From: Griffin, Tim
Sent: 27 April 2024 13:56
To: Jacob Goodenough
Cc: Osmond, Gary; Dyer, Tim; Ellison, Mark; Oliveira, Marta
Subject: Re: RM/24/96684 NETLEY FIRS, KANES HILL, SOUTHAMPTON, SO19 6AJ - landscape comments

DD650L01B_Landscape General Arr

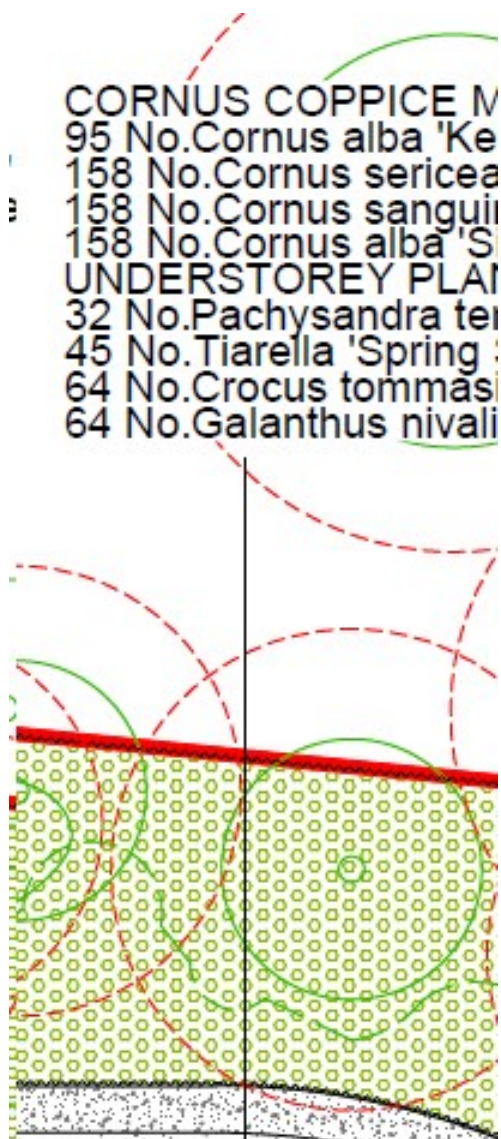
1/ There is an over-reliance on the Cornus Coppice Mix. In some places this mix is used immediately adjacent parking bays/building lines which will increase maintenance work as Cornus spp. will have to be regularly coppiced. Please review the plan and introduce another lower mix (including some evergreen species - e.g. some ornamental species such as Lonicera 'Maygreen', Hebe 'White Gem', Leucothoe axillaris 'Little Flames' etc.) alongside parking spaces.

Where the Cornus mix is used adjacent to parking spaces, we have left a 500mm offset between the kerb and the planting area, shown as loose gravel infil. This is to allow space for car doors etc. to open, to avoid clash with parking bays. Please see screenshot below, with offset circled in blue.

The Cornus mix is proposed as an attractive a low-maintenance solution with all-season visual interest, from the coloured stems in winter through late spring flowering and in leaf until autumn. It will not require any coppicing for the first 2 years whilst it establishes, and then required only 1 cut annually (every 2 years if longer stems are preferred, or on rotation to maintain 50% coverage at all times.) in late March. Additional seasonal interest and ground cover is provided by the understorey planting.

The 500mm offset is noted and I can see the point of a low maintenance, all season interest species mix. My issue is with the over-use of the Cornus coppice mix. Please introduce another low maintenance, all season mix in places. Possibly the smaller beds in the parking areas?

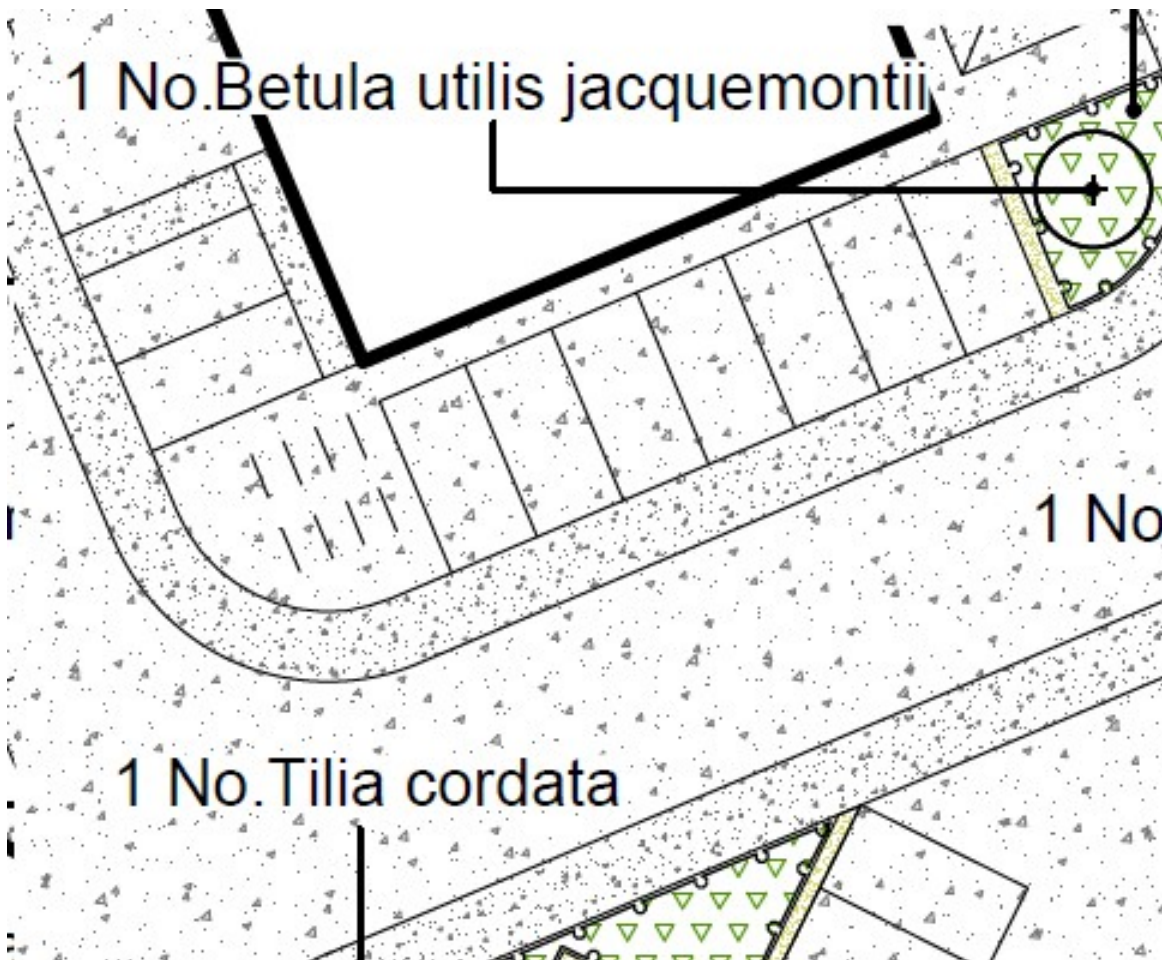
2/ The area of Cornus Coppice Mix below needs to be adjusted to include some evergreen species to ensure screening during winter months in views from the main road:

50% of mix min. to be evergreen. Species such as *Prunus lusitanica*, *Laurus nobilis*, *Viburnum tinus* and *Ligustrum vulgare* etc. Locate to particularly terminate view from the road down the access path into the site.

We can add some additional evergreen shrubs here: We will avoid the Portuguese and Cherry Laurel suggested however but happy to introduce *Viburnum tinus* and additional evergreen shrubs that will work well with the coloured cornus stems, potentially adding *illex* and *taxus* to tie-in with the semi-natural site boundary to the road.

Viburnum, Ilex and Taxus all good and possibly some native Ligustrum? Min. 50% of mix to ensure year-round screening.

My comments below focus on the plan prepared by Deacon Design DD650 L01 (no revision - note: drawing for some reason not titled but I assume this is the detailed landscape plan?).

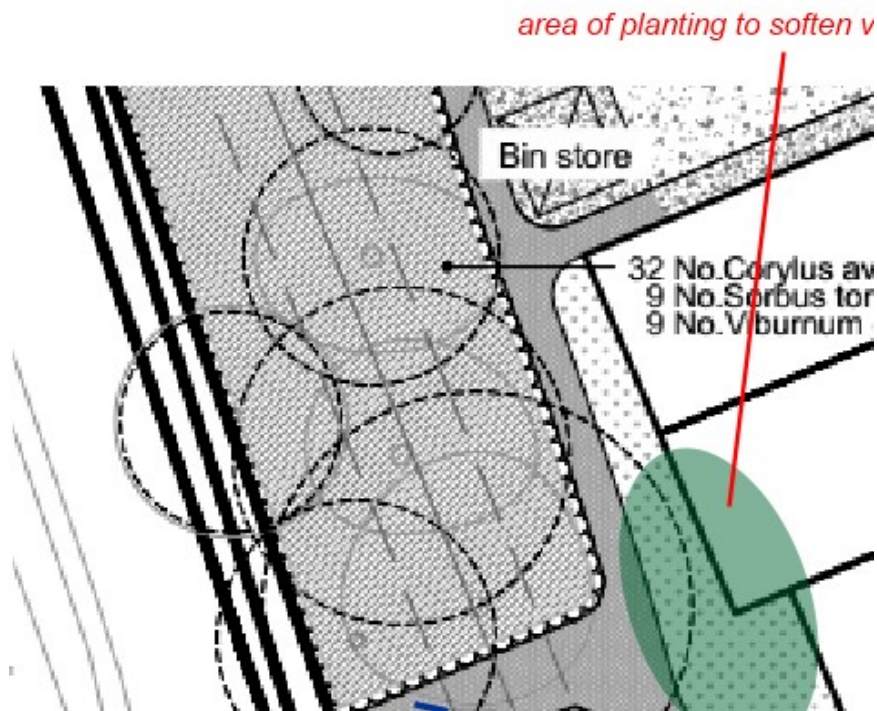
a/ The existing boundary vegetation along the frontage to Kaneshill performs an extremely important role in screening the site. I am concerned that the notional symbol used to indicate the extent of this planting is too vague and may not reflect the on-ground situation. Looking at street view images on line there are considerable stretches of Rhododendron that perform an important year round screening role.

Please can we ask the designers to update the drawing to show the extent of existing vegetation more accurately, especially the understorey growth, so that any gaps/areas of thinner screening can be clearly shown on plan (this also applies to the boundary vegetation shown on the N & E of the site). This will then allow a more targeted specification of new screen planting in locations where it is most needed. This may require further survey work on site unless the existing topographical plan has already picked up the understorey accurately.

At present the notes on plan regarding this band of vegetation are too general and there is no way of assessing if the numbers of understorey planting allowed to fill gaps is sufficient or not. The species mix shown is curious. A % of evergreen screening plants should be included and some more obvious deciduous options such as Hawthorn. It would also be worth including a % of canopy tree species (especially Oaks) to ensure long term succession.

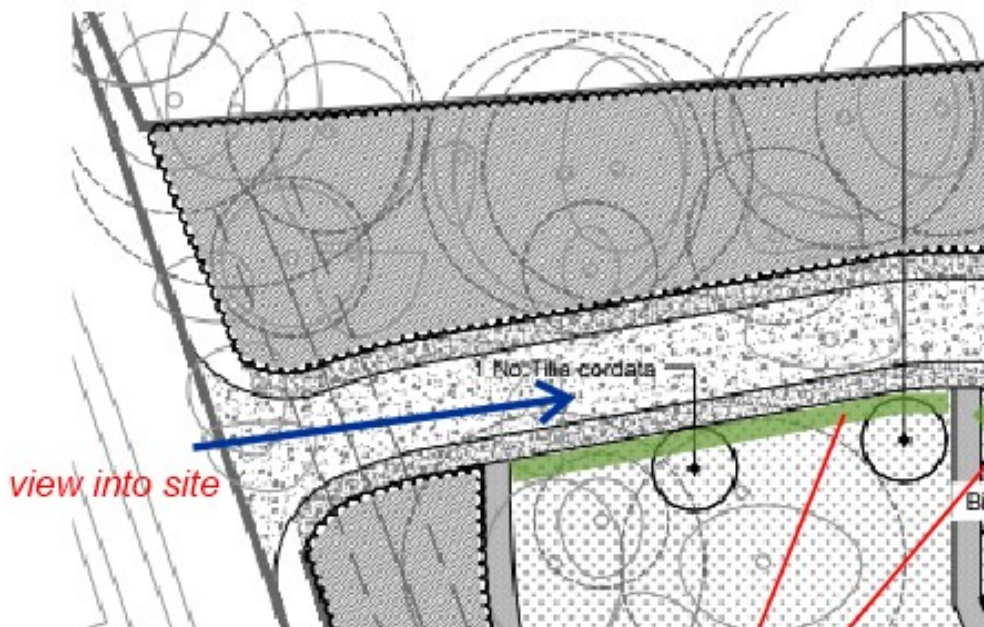
b/ The installation of a new link path onto Kanes Hill will open up a direct view into the site. An area of planting adjacent Units 6-8 will help reduce visual impact. This could be native understorey type planting or perhaps a mix of large evergreen shrubs.

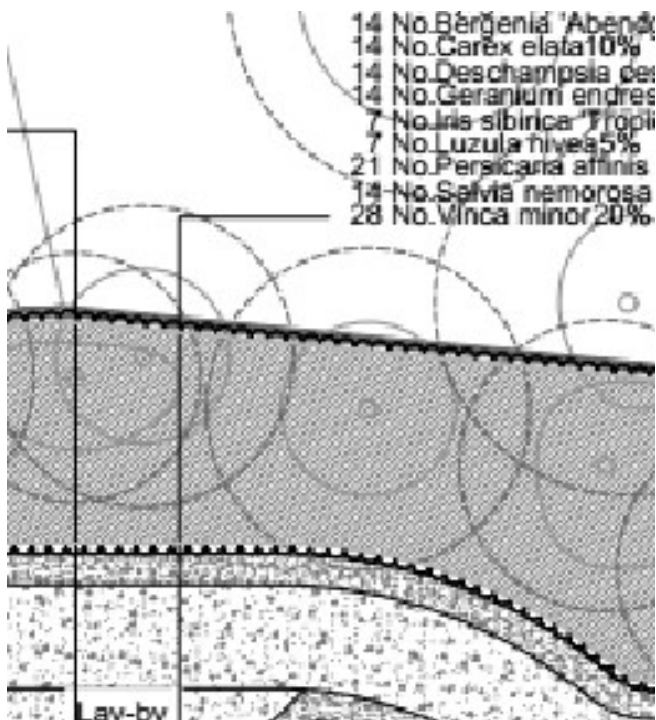
c/ A further oblique view into the site will occur down the driveway. Additional native mix hedge planting as shown below will help soften this view:
